ARM940T Rev.2v2 Errata ListARM940T Rev.2v2 Errata List

Document number: ARM940T-PRDC-000610 2.0
Date of Issue: 17th December 2001
Author: Paul Garden
Authorized by: Jason Ackroyd

This document describes the known errata in the ARM940T Rev 2 v2 design.

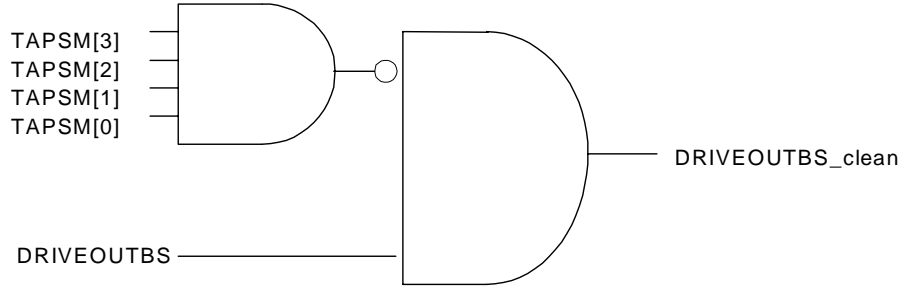
In normal use, the TAP controller is reset only during a system reset. Under this circumstance a DRIVEOUTBS being asserted will not cause a system failure, since the system itself is being reset.

However during debug operation the TAP controller may be reset independently of a system reset. In this case, if TMS is used as the mechanism for causing the TAP controller to enter the reset state then DRIVEOUTBS will be incorrectly asserted. When DRIVEOUTBS is asserted the external scan chains will select the scan path and this could cause incorrect operation of the device.

The following external logic should be added to ensure correct operation of DRIVEOUTBS.

`DRIVEOUTBS_clean = (TAPSM != 4'b1111) & DRIVEOUTBS`

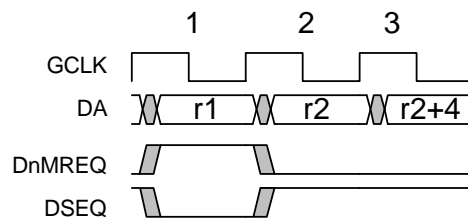
A coprocessor memory transfer instruction (LDC or STC) can incorrectly have its first access (a non-sequential access) marked as being sequential.

For the first memory transfer of any memory instruction the ARM9TDMI should indicate on its data memory request signals that the transfer is non-sequential. This is indicated by DSEQ being low during this first memory access. However there is a particular situation for a LDC or STC instruction where its first memory transfer can incorrectly be marked as sequential. This case can only be invoked if a LDC or STC instruction, which fails its condition codes, is directly followed by a second LDC or STC instruction which passes its condition codes. For the precise conditions required see below.

During cycle (1) in the diagram above, the DnMREQ is high and DSEQ is low, indicating an IDLE cycle. This corresponds to the IDLE cycle generated by the LDC which fails its condition code check. In cycle (2) the first memory transfer for the second LDC occurs. In cycle DSEQ is incorrectly high, marking the transfer as being sequential.

If a coprocessor is attached with can execute LDC or STC instructions then this errata only applies if the coprocessor can execute an LDC or STC without busy-waiting the processor first. Thus a hardware workaround is to ensure all attached coprocessors insert a busy wait cycle before executing a LDC or STC.

A second work around is to ensure that the code does not contain a sequential instruction pair of LDC or STC instructions where it is possible for the first instruction to fail its condition code check and for the second to pass its condition code check.
